Subject: Field Repair 34-087 – Model 520 Right Hand Stand-Up (RHSU) Door Alarm  
EXPIRATION DATE: 7/1/2021

**34-087**

Model 520 Right Hand Stand-Up (RHSU) Door Alarm

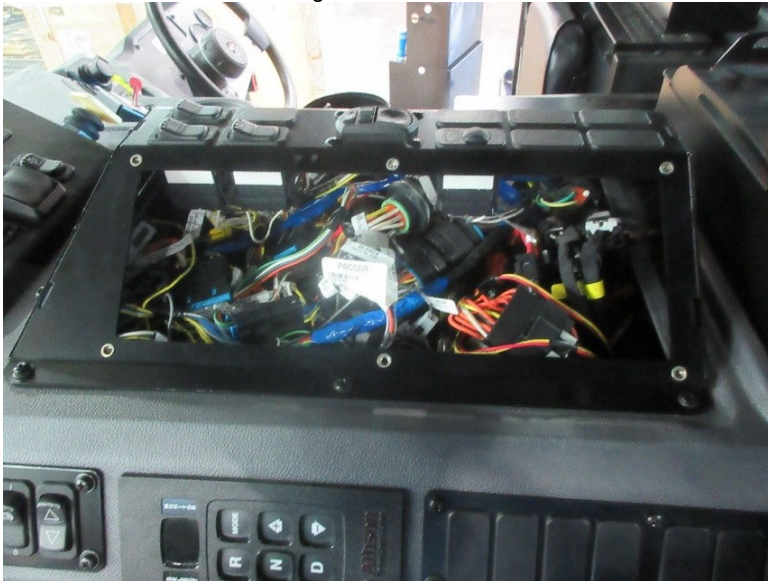
1. Remove the cover from the doghouse to access Main Cab Harness S92-6361 and Work Brake Harness S92-6017.

2. Connect the Door Alarm Override Harness connector J001 (PASS DOOR JAMB INT) to the Main Cab Harness connector P101 (PASS DOOR JAMB INT).
3. Connect the Door Alarm Override Harness connector P001 (PASS DOOR JAMB INT) to the Main Cab Harness connector J101 (PASS DOOR JAMB INT).
4. Connect the Door Alarm Override Harness connector T001 (FBO INST. GROUND) to the Main Cab Harness connector J041 PIN A (FBO INST. GROUND).
5. Connect the Door Alarm Override Harness connector J002 (MAIN CAB WORKBRAKE) to the Main Cab Harness connector P075 (TO WORK BRAKE HARNESS).
6. Connect the Door Alarm Override Harness connector P002 (TO WORKBRAKE HARNESS) to the Workbrake Harness connector J1 (MAIN CAB WORKBRAKE).
7. Tuck the harnesses back into the doghouse and reinstall the doghouse cover.
